# Access Compliance Report

## Public Rights-of-Way

### (Curb Ramps)

Intersection ID: 13149	Main Street: CENTRAL_AV	Cross Street: THE_PLAZA	Location: NW
ADA ID: 5371403AEDCB	Ramp Type: Perp	Initial Pass/Fail: Fail	Overall Compliance: No
			Severity Score: 48.75

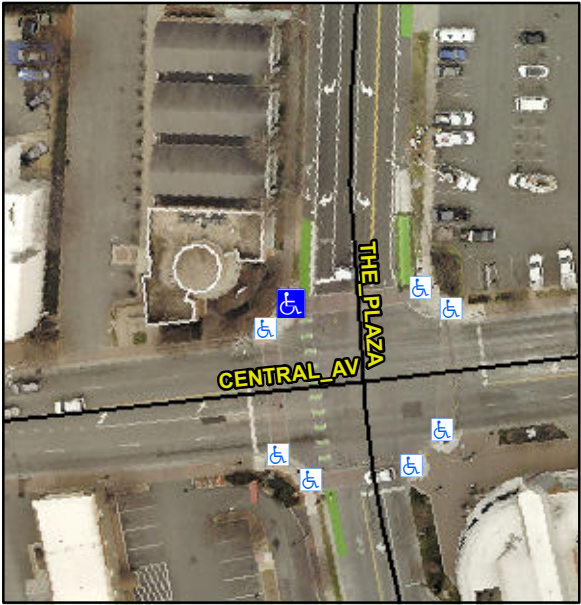
Codes/Mitigation Info/Possible Solution			Field Measurements/Component Compliance		
	Possible Solutions:		<b>Compliance</b>	<b>Description</b>	<b>Data</b>
	<b>Remove &amp; Replace Entire Ramp.</b>		<b>No</b>	Ramp Length (in)	81.0
			<b>No</b>	Ramp Width (in)	30.0
			<b>N/A</b>	Flare Type LT	N/A
			<b>N/A</b>	Flare Slope LT (%)	N/A
			<b>N/A</b>	Flare Traversable LT?	N/A
			<b>N/A</b>	Landing Length (in)	N/A
			<b>N/A</b>	Landing Width (in)	N/A
			<b>N/A</b>	Landing Slope (%)	N/A
			<b>N/A</b>	Landing X Slope (%)	N/A
<p>Surveyor Notes:</p> <p><b>N/A</b></p> <p>PROW/ADA:</p> <p><b>Not Found, R304.5.1, R304.2.2, R304.5.3</b></p>			<b>N/A</b>	Flare Type RT	N/A
			<b>N/A</b>	Flare Slope RT (%)	N/A
			<b>N/A</b>	Flare Traversable RT?	N/A
			<b>N/A</b>	DWS Provided?	N/A
			<b>N/A</b>	DWS Contrast?	N/A
			<b>N/A</b>	DWS Length (in)	N/A
			<b>N/A</b>	DWS Full Width?	N/A
			<b>N/A</b>	DWS Offset (in)	N/A
			<b>N/A</b>	Shared Landing?	N/A
